Economic Commission for Europe**Inland Transport Committee****World Forum for Harmonization of Vehicle Regulations****Working Party on Passive Safety****Sixty-fifth session**

UN Regulation No. 17 (Strength of seats)**Proposal for the 10 series of amendments to UN Regulation No. 17 (Strength of seats)****Submitted by the expert from the European Association of Automotive Suppliers***

The text reproduced below was prepared by the expert from the European Association of Automotive Suppliers (CLEPA) to amend the static options of the draft 10 series of amendments submitted by the experts from Japan and the European Commission (ECE/TRANS/WP.29/GRSP/2018/34). It is based on informal document GRSP-64-25 presented during the sixty-fourth session of the Working Party on General Safety (GRSP). The modifications to ECE/TRANS/WP.29/GRSP/2018/34, are marked in bold or strikethrough characters.

**"Figure 8-3
Portion of gap above 540mm**

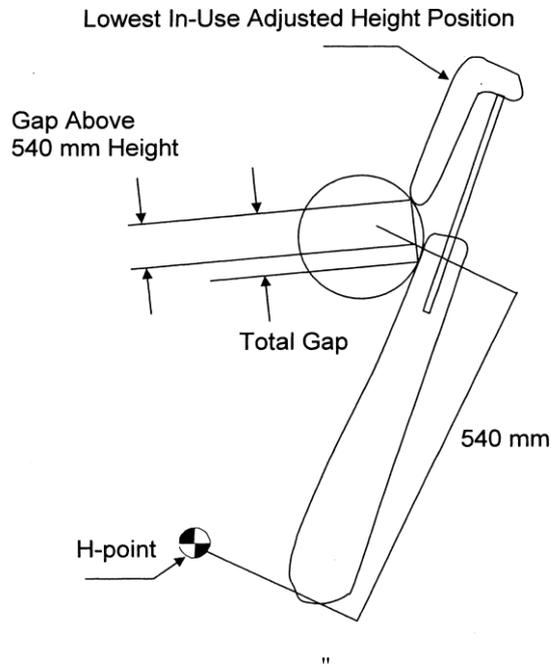
- "2.3. The area of measurement is anywhere between two vertical longitudinal planes passing at 85 mm on either side of the torso line and above ~~the top of the seat back~~ **a height greater than 540 mm."**

- "2.5. Determine the gap dimension by measuring the straight line distance between the inner edges of the two furthest contact points, as shown in Figures 8-1, ~~and 8-2 and 8-3."~~

Annex 8, insert new Figure 8-3, to read:

"Figure 15 – 1.

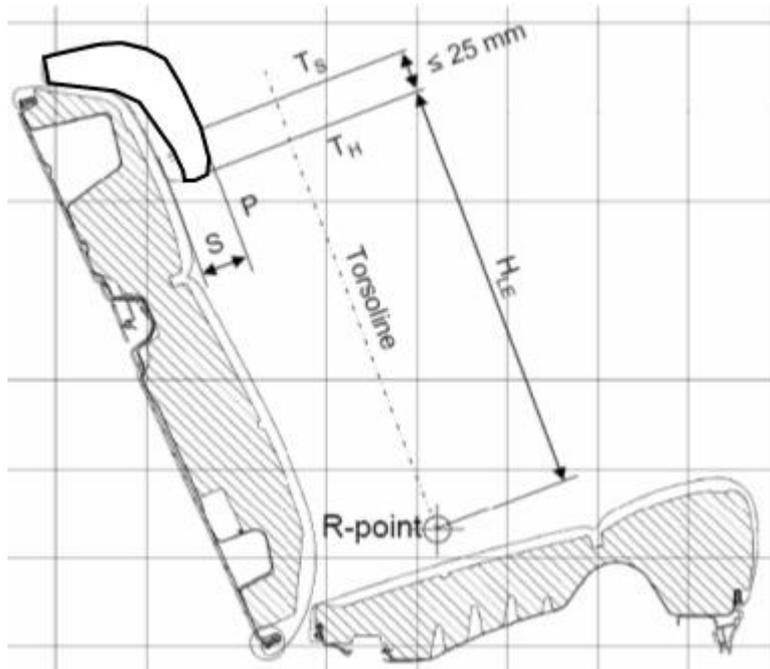
Annex 15, figure 15-1, amend to read:
